TECH TIP for aluminum steering blocks V2 (352256 & 352266)

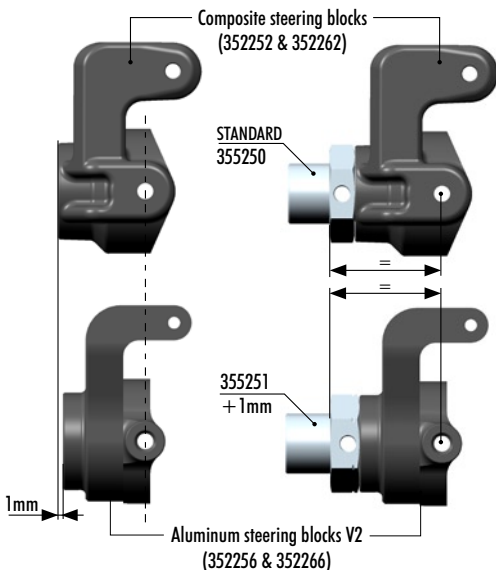
The new Alu Steering Block V2 is 1mm narrower than the composite steering block (352252 & 352262). To get the same offset, use the #355251 Alu Wheel Axle Offset +1mm.

For Aluminum Steering Blocks V2 (352256 & 352266) and for the 5° Kingpin Steering Blocks (352257 & 352267). All wheels have different-sized ribs on the inside of the wheel. When using some wheels with larger ribs, those ribs may contact the suspension arm when the wheels are turned to full steer. In this case, we recommend using the following to prevent the ribs from touching the arm (depending on the wheel used):

- a.. #335251 Alu Wheel Axle Offset +1mm
- b.. #335252 Alu Wheel Axle Offset +2mm
- c.. #335253 Alu Wheel Axle Offset +3mm
